**Region 6 Compliance Assurance and Enforcement Division
INSPECTION REPORT**

Inspection Date(s):	November 15–18, 2021		
Media:	Water		
Regulatory Program(s)	CWA		
Company Name:	Total Environmental Solutions, Inc. (TESI)		
Facility Name:	Multiple – see attached spreadsheet – Attachment 1		
Facility Physical Location:	Multiple – see attached spreadsheet – Attachment 1		
(city, state, zip code)			
Mailing address:	PO Box 14059		
(city, state, zip code)	Baton Rouge, LA 70898		
County/Parish:			
Facility Contact:	Gayle Davidson	Compliance Manager	
	gdavidson@tesi-usa.com		
FRS Number:	110009924403		
Identification/Permit Number:	Multiple – see attached spreadsheet – Attachment 1		
Media Number:			
NAICS:			
SIC:	4952		
Personnel participating in inspection:			
Kenneth AuBuchon	EPA-R6/EN-WM	Environmental Engineer	281-983-2151
Lawrence Messmer	TESI	Operations Manager	337-316-2925
Wendy Cahanin	TESI	Project Assist	337-319-1530
Earl Hayes (“Fig”)	TESI	Lead Operator	337-319-1530
Kathryn Sparks	TESI	Operator	985-466-0009

Crozier Heights / LAG560179 / 11/15/2021

Frenchman's Creek / LA0077798 / 11/17/2021

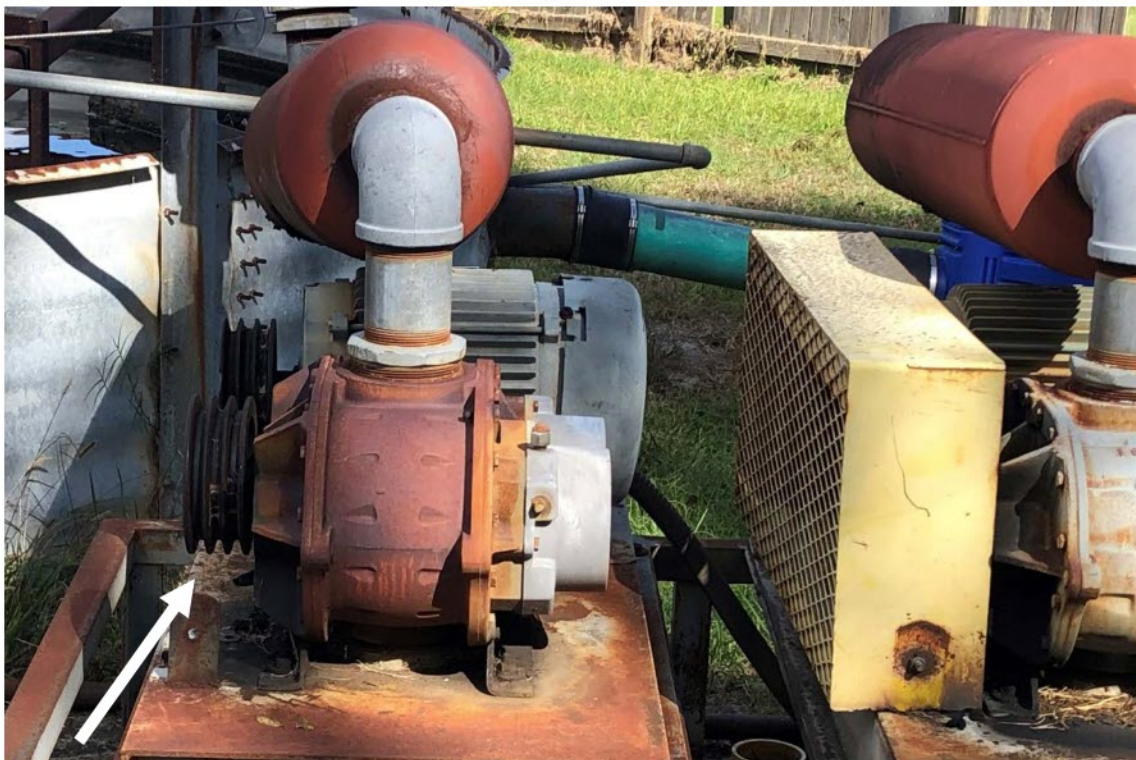
1. Observed unknown 2-inch pipe at the Chlorine Contact Chamber (see picture below).

2. Solids in the Chlorine Contact Chamber (see pictures below).

3. Aeration blow was not in working condition due to missing belt (see picture below).

4. Skimmer not functioning correctly due to buildup of debris (see pictures below).

Arrowhead 1 & 2 / LA0062791 / 11/17/2021**Areas of Concern:**

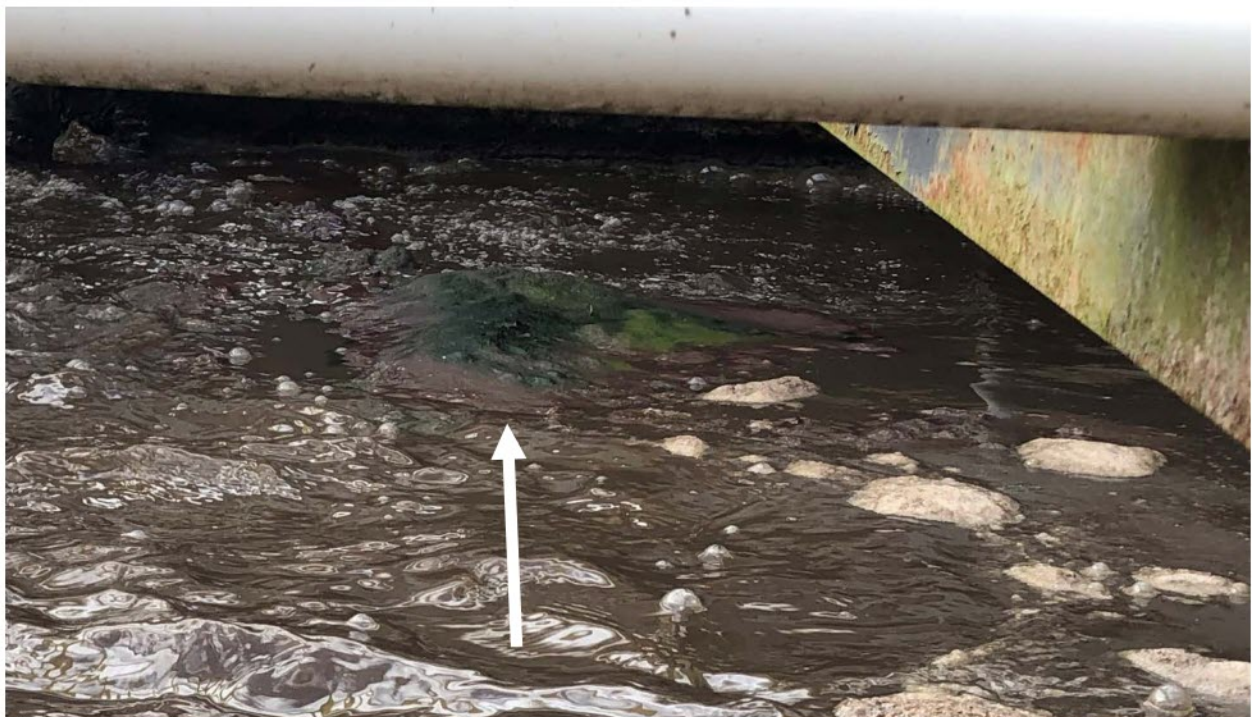
1. Solids in the Chlorine Contact Chamber of Arrowhead #2 STP (see picture below).

2. Solids in the Chlorine Contact Chamber of Arrowhead #1 STP. Chamber was cloudy with solids due to aeration (see picture below).

3. Large mass of debris observed in the aeration chamber of Arrowhead #1 STP (see picture below).

4. Sludge observed in the receiving ditch (see pictures below).

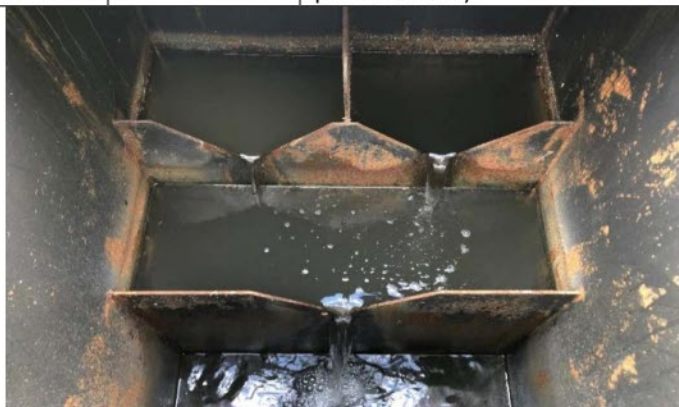
Job to complete	Date completed	Job completion Information
Chlorine Contact Chamber Install caps on chlorine tubes.	1/8/2018	Complete as per request
Safety/STP Repair holes in clarifier/aeration wall.	1/23/2018	Complete as per request
Clarifier Repair inlet baffle skimmer.	9/20/2018	Complete as per request
Clarifier Level Overflow Weir	6/30/2017	Unknown date confirmed on Audit date/ completed
Discharge Install v-notch sample box or other flow measurement system	1/27/2021	Delayed due to weather and Contractor Scheduled for 5-1-21. Unknown date completed/confirmed on date of Audit (see picture below)

Lanexang Village 1 & 2 / LAG540108 / 11/17/2021**Areas of Concern:**

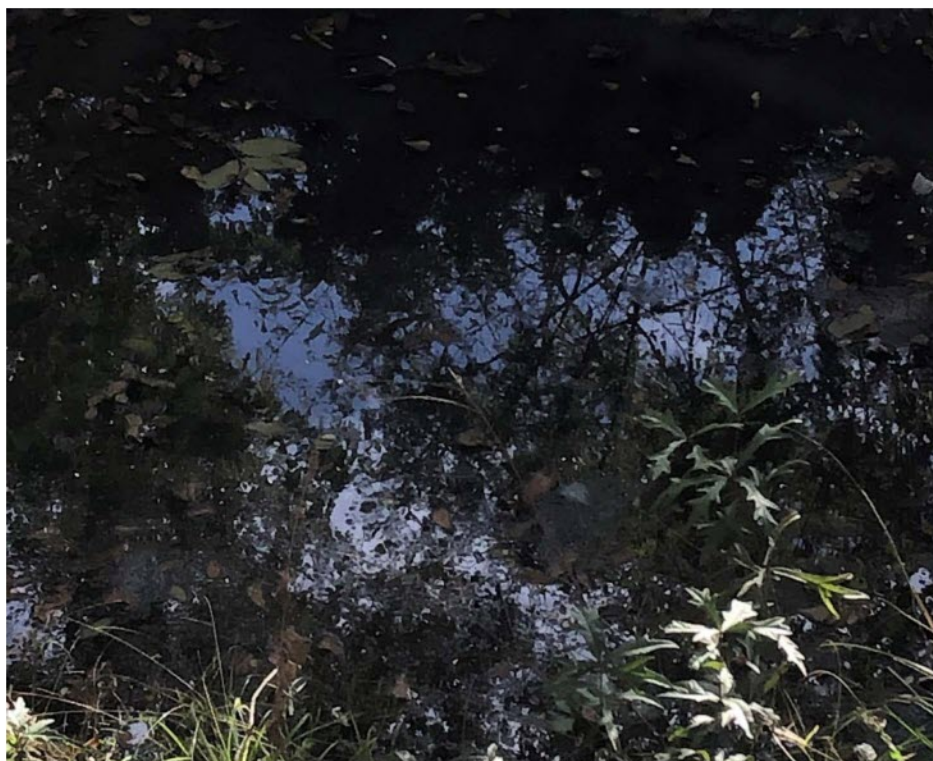
1. Sludge observed in the receiving ditch (see picture below).
